# SERVICE BULLETIN

Machines/Models: MX15  
MX19

SB97.3

**PURPOSE:** Add a diode to the electrical circuit to protect the down alarm from voltage spikes.

*Figure 1*

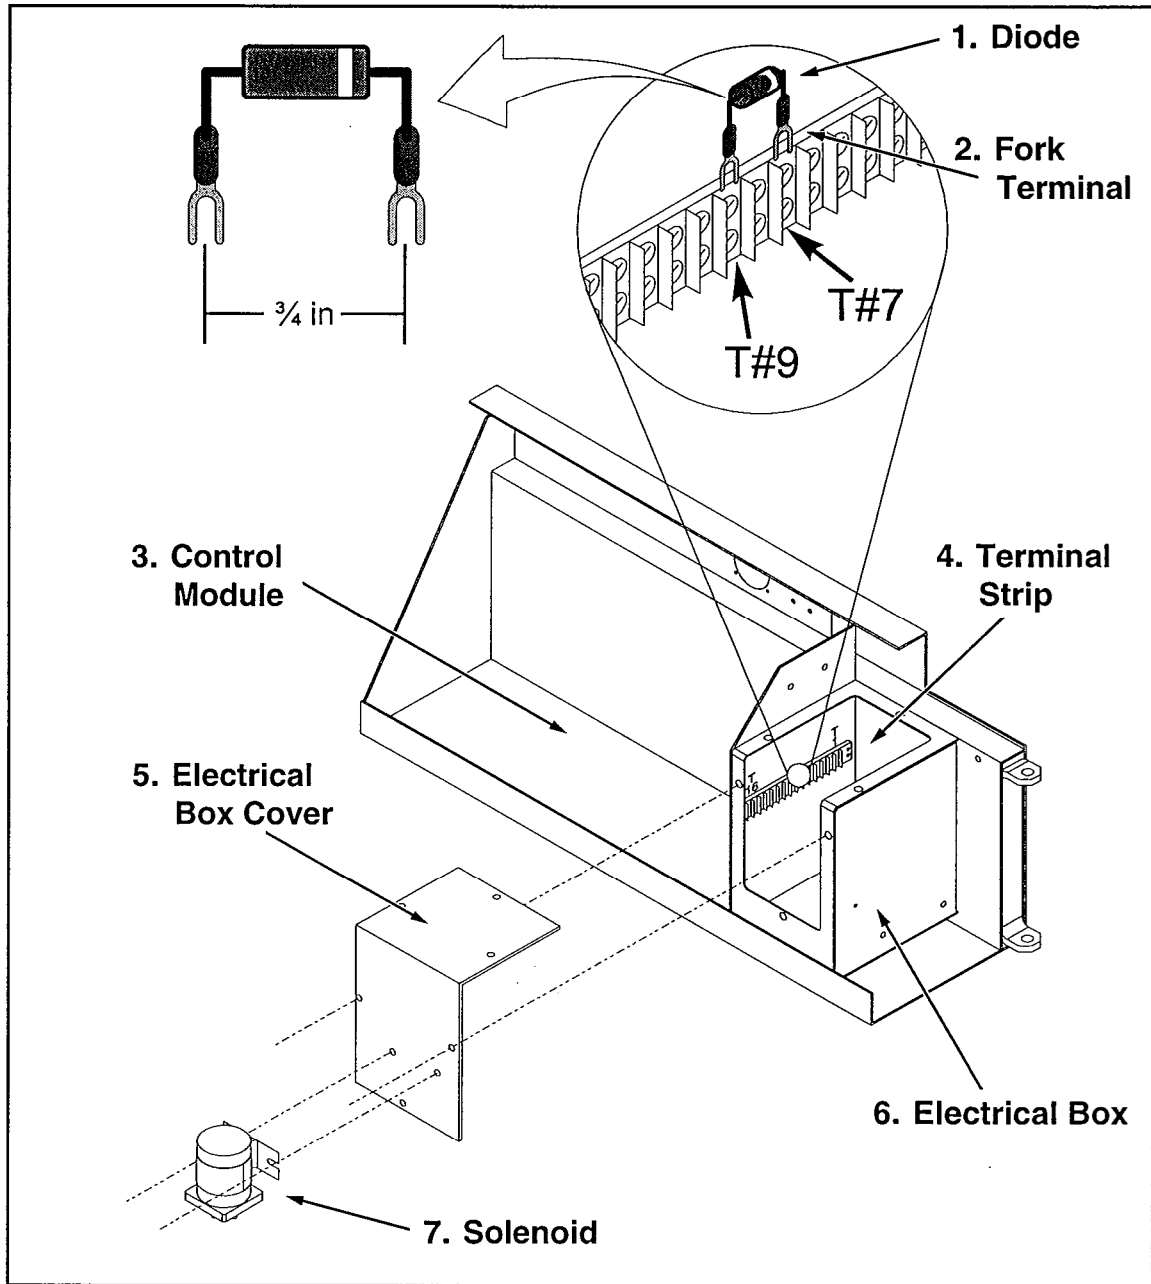
**PROCEDURE:** Read all instructions thoroughly and refer to figure 1 before starting.

1. Disconnect the negative battery terminal from the battery.
2. Remove the two mounting screws from the solenoid (#7), and lay it aside leaving the wires attached.
3. Remove the six screws from the electrical box cover (#5) and remove the cover.
4. Crimp the fork terminals (#2) to the ends of the diode (#1) and form the leads to fit 3/4 inch spacing (on center).
5. Install the diode to terminals seven (7) and nine (9) on the terminal strip (#4) per figure 1. Insure that the diode is installed with the stripe toward terminal seven (7). Terminals are numbered from right to left as you face the terminal strip (#4).
6. Replace the electrical box cover (#5) and screws.
7. Replace the solenoid (#7) and mounting screws.
8. Replace the negative battery cable.
9. Test all functions of the machine.
